**Technical Service
Information Bulletin**

**TRUNK WILL NOT OPEN WHEN USING
REMOTE OR INTERIOR SWITCH**

'07 LS 460

ELECTRICAL
EL012-07

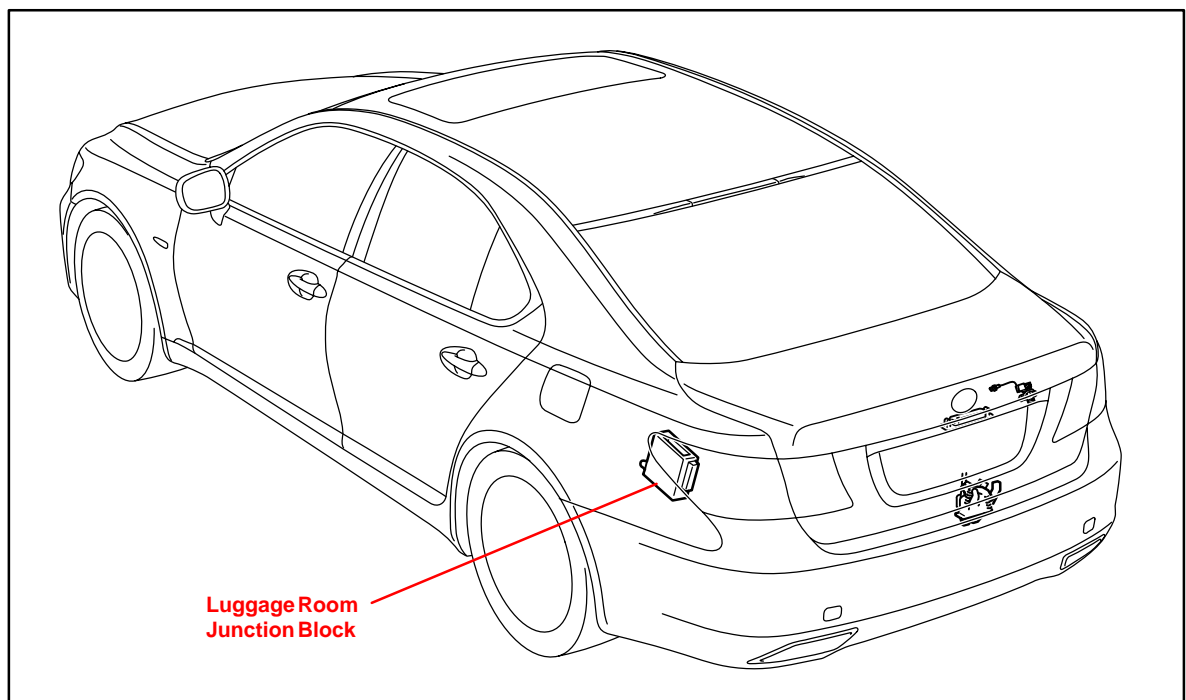
Introduction Customers may complain that the trunk is stuck closed and will not open when using the remote or interior switch. The trunk can continue to be opened using the key or interior safety pull. A new luggage room Junction Block has been developed to correct this condition. Use the following repair procedure to replace the luggage room Junction Block.

1. Record radio presets.
2. Gain access to the trunk by using the mechanical key. Turn the mechanical key clockwise to open.

3. Disconnect the battery.
4. Remove the LH luggage room trim panel.
5. Replace the luggage room Junction Block.

6. Install the LH luggage room trim panel.
7. Reconnect the battery.
